**EXH. KKD-4
DOCKET UE-210795
PSE'S CEIP
WITNESS: KARA K. DURBIN**

**Clean Energy Implementation Plan
Pursuant to WAC 480-100-640**

PSE RESPONSE TO PUBLIC
COMMENTS ON ELCC
CALCULATIONS AND USE

December 3, 2021

Figure 2. Dispatch Plot, Week of January 25 (2027), PSE IRP Base Case

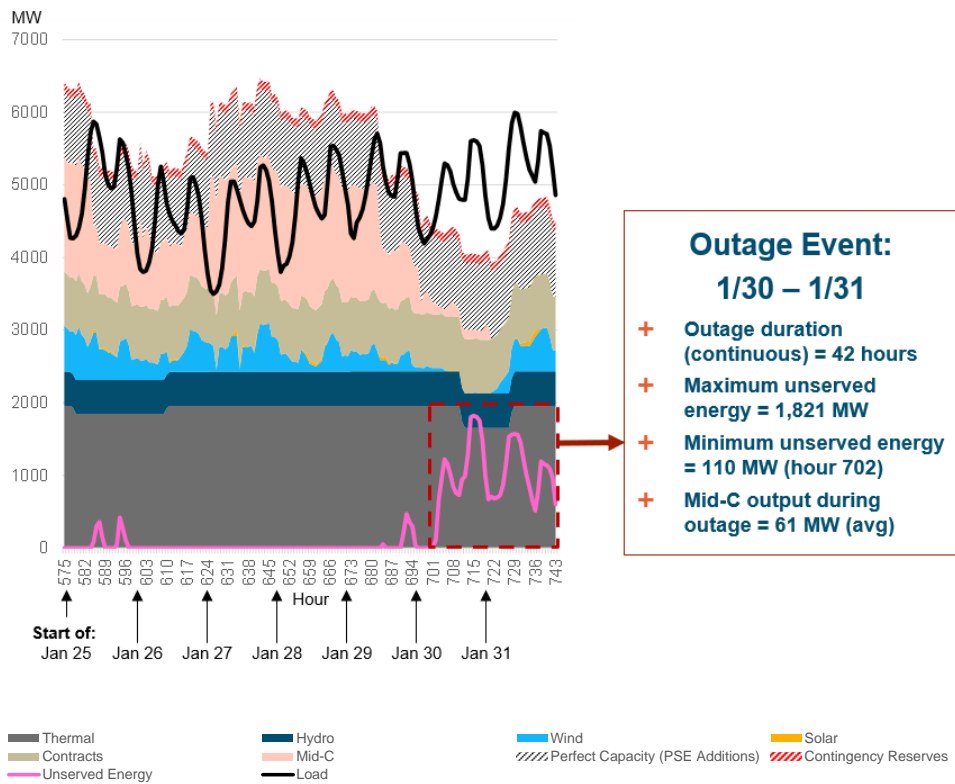
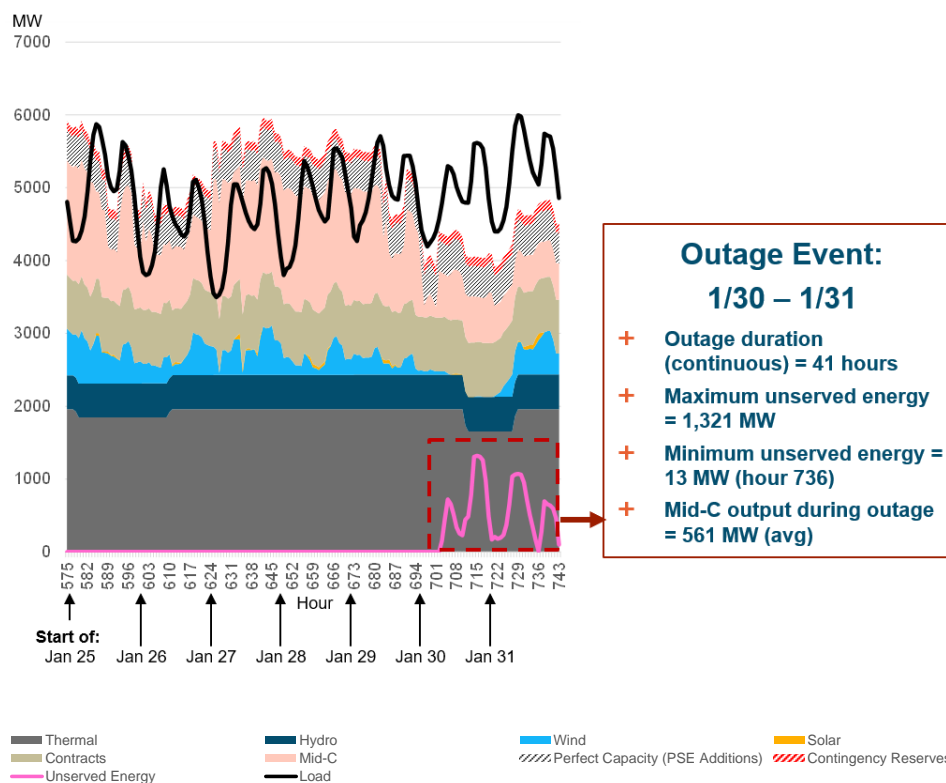
To illustrate the impact of potential additions to regional capacity, E3 generated the dispatch plots below from the week of January 25, 2027 in the PSE Base Case. This week was chosen because of a 42-hour outage that occurs in draw 1687 (out of 7040), representing the combination of hydro calendar year 1947 (in which streamflow was the lowest of all 80 hydro years) and temperature calendar year 1943. In Figure 2, PSE's modeled dispatch is shown. In Figure 3, E3 has added 500

As shown above, modifying the PSE Base Case so that Mid-C output is increased by 500 MW during unserved energy events reduces the duration of the 42-hour outage by only 1 hour, illustrating the impact of Mid-C on the outage characteristics against which battery storage is tested. However, it can also be seen that increasing the Mid-C market availability by an additional 500 MW would reduce outage durations substantially by effectively segmenting the long-duration outage shown above into multiple smaller-duration outages.

To assess the potential impact of changes in PSE's approach to the external market on ELCC values, E3 recommends an additional GENESYS model run (and subsequent calibration with the WPCM model) where reliability-driven capacity is added to the broader region to achieve a 5% LOLP, as well as the PSE system. PSE should then perform ELCC calculations with a reliable system (to a 5% LOLP standard) where both the Mid-C market and PSE system are in a reliable state. How the battery storage ELCCs change could inform how PSE possibly rethinks its current modeling of the Mid-C market. If the changes to ELCC results are negligible then PSE would be comfortable that its current modeling is sufficient. If the ELCC results change significantly then broader consideration would need to be given to what reliability standard (and relatedly how much added reliability-driven capacity) is reasonable to assume given PSE's expectations for future capacity additions and retirements in the region.

Figure 4. Dispatch Plot, Week of January 14 (2027), PSE IRP Base Case

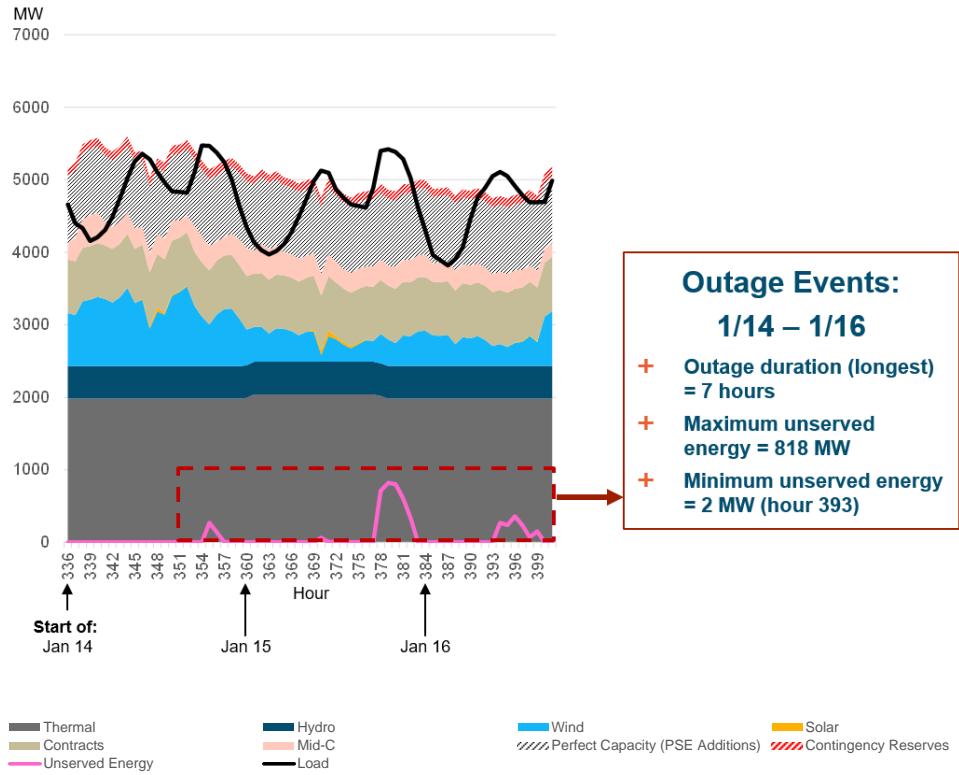
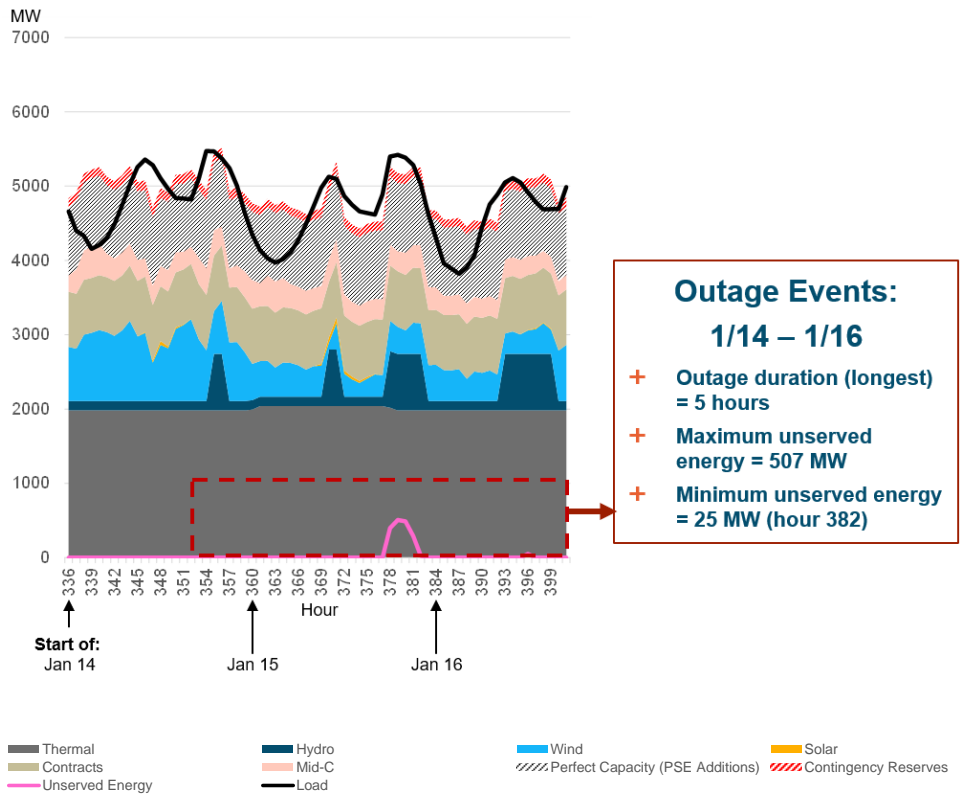
To illustrate the impact of changes in PSE's approach to modeling hydro operations, E3 generated the dispatch plots below from the week of January 14, 2027 in the PSE Base Case. This week was chosen because it contains multiple shorter-duration outages in draw 1687 (out of 7040), representing the combination of hydro calendar year 1947 (in which streamflow was the lowest of all 80 hydro years) and temperature calendar year 1943. In Figure 4, PSE's modeled dispatch is shown. In Figure 5, E3 has modified the capabilities of hydro resources to operate with energy limitations (50% capacity factor, p_{min} of 25%) and dispatch capabilities (i.e. output can be increased to p_{max} when there is unserved energy).

As shown above, modifying hydro resources so they are energy-limited and dispatchable illustrates the ability of hydro to minimize unserved energy needs over shorter-duration periods (e.g., 4-6 hours).

For future IRP cycles, E3 recommends that PSE update its modeling to incorporate hydro dispatch capabilities and hydro energy limitations. E3 recognizes, however, that modeling hydro as flexible is highly complex, as the flexibility depends on water conditions, operational constraints, and other factors that are difficult to quantify in a planning model.

The current model takes daily hydro data for each of the 80 hydro years that corresponds to GENESYS. E3 suggested incorporating dispatch into the model to reflect how the hydro can be moved to balance load by hour. This will give more flexibility to the hydro and most likely lower the ELCC to storage. As E3 recognizes, modeling hydro as flexible is highly complex, because the flexibility depends on water conditions, operational constraints, and other factors that are difficult to quantify in a planning model. Additionally, this modeling approach will require PSE to move the model out of Python to a production cost model such as Plexos. Given the lead time needed to build a new resource adequacy model and the uncertainty around the NWPP Resource Adequacy program, it will not be feasible to incorporate this recommendation for Phase 2 of the RFP or the 2023 Electric IRP progress report. Therefore, consistent with E3's recommendation, PSE will explore this recommendation in future IRP cycles.

Figure 6. PSE Temperature Year Data, by Source

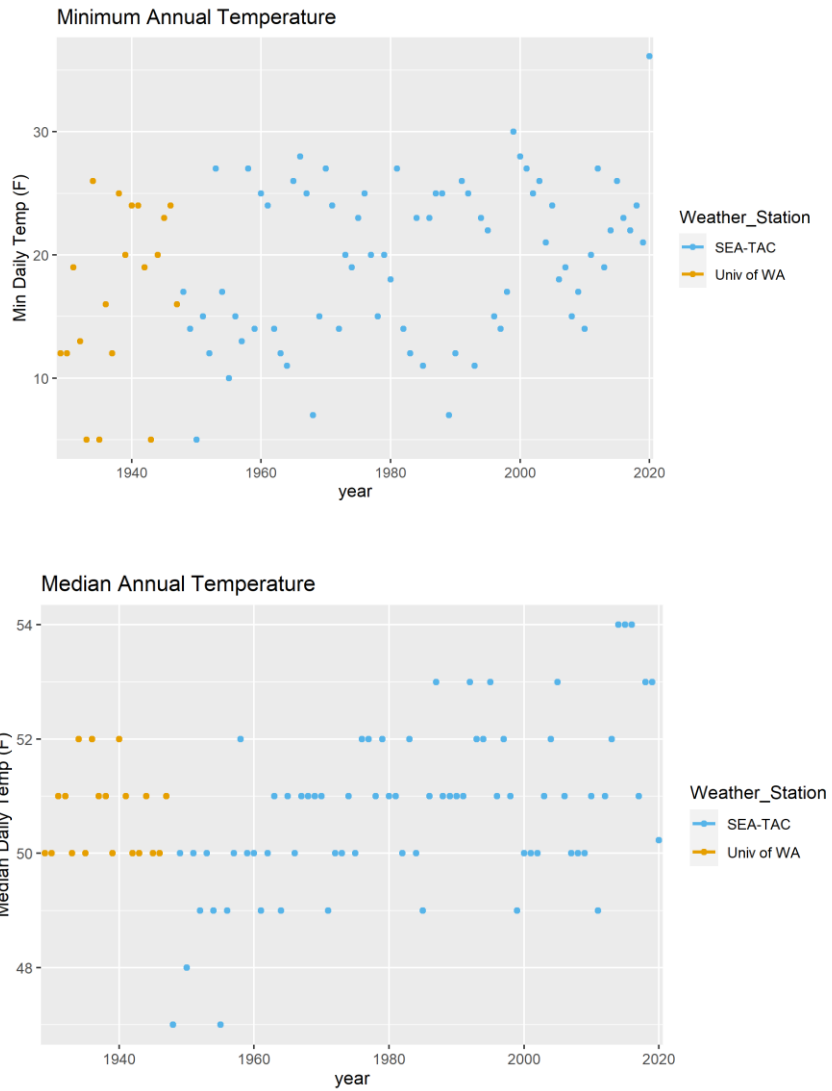
This brings up important questions regarding whether the synthesized hourly temperature data is having an impact on PSE's modeling and ELCC analysis. Unlike the outage events across hydro input years that are relatively evenly distributed, outage events in PSE's modeling are not evenly distributed across temperature input years. 33% - 35% of the simulated draws that have loss of load events in January 2027 and January 2031 occur in the temperature years prior to 1948, a period representing 21% of all weather years.

However, E3 analyzed this pre-1948 temperature data and found that it is reasonable and does not demonstrate any apparent bias compared to the other temperature years that would unfairly impact ELCC results. The minimum annual temperatures, as well as the median temperatures do not show a clear bias in the data that is formed with the synthesized data.

Figure 7. Number of PSE Base Case Draws With Loss of Load Events, by Temperature Year, January 2027 and 2031

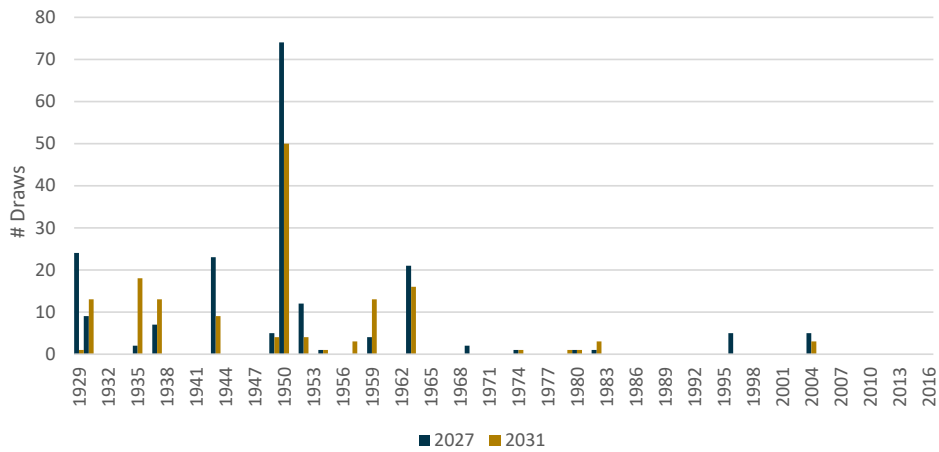
But looking at the temperature data further reveals that nearly 95% of the simulated draws that have loss-of-load events in January 2027 and January 2031 occur in the first half of the temperature years, prior to 1972 (see Figure 7).

This raises important questions regarding whether, given that PSE is a winter-peaking system, there are clear warming trends that make the use of temperature data as far back as 1929 less useful. Moving forward, PSE’s winter peaks may be reduced relative to summer peaks based on more recent climate warming trends, which has the potential to impact PSE’s resource planning.
